Project: San Jacinto River Waste Pits Superfund Site
Project #090557-01

Subject: Draft Meeting Minutes - Kickoff Meeting for Task 1 of the AOC
Wednesday, May 12, 2010, EPA Offices, Dallas, Texas

Figure 1
Alternative 1 Plan View
East and West Impoundment Sheet Pile
SJRWP TCRA

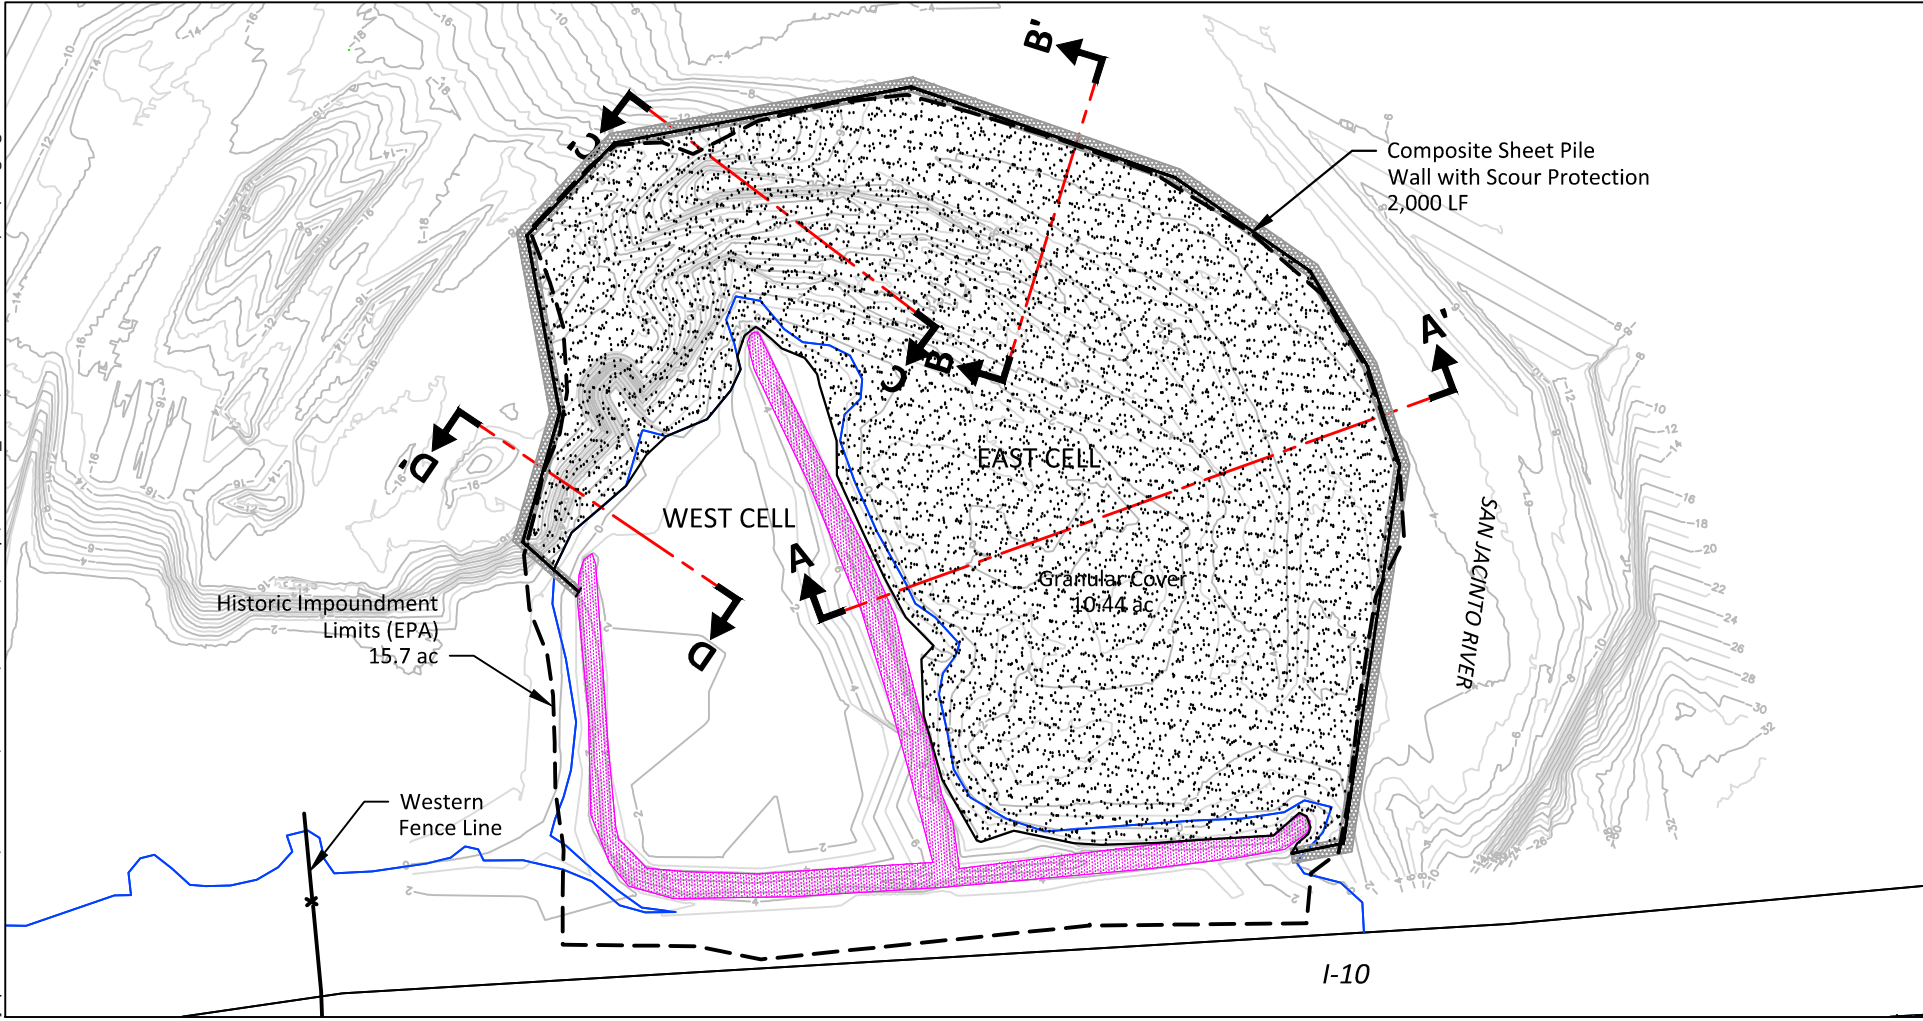
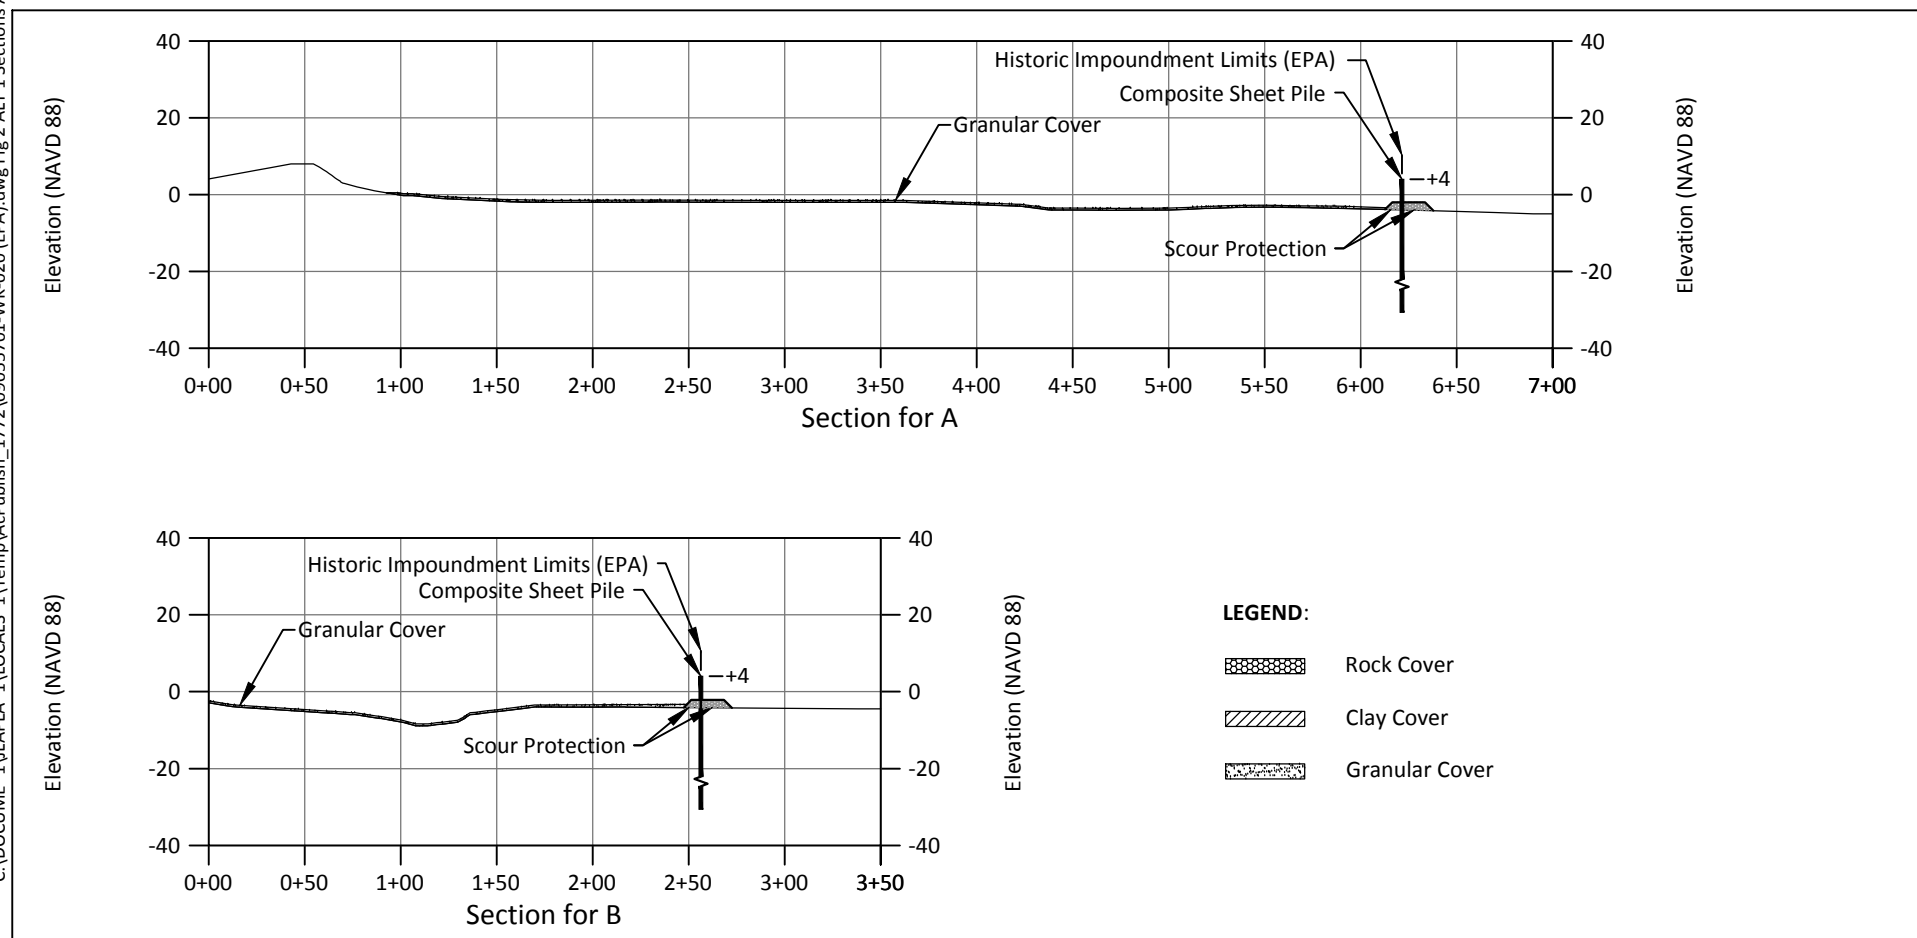
- Discussed rationale on why vegetation in western cell is sufficient for the TCRA. The EPA suggests covering the leading edge of the west cell in the RP's alternative 1, vinyl sheet pile around the 1966 footprint.
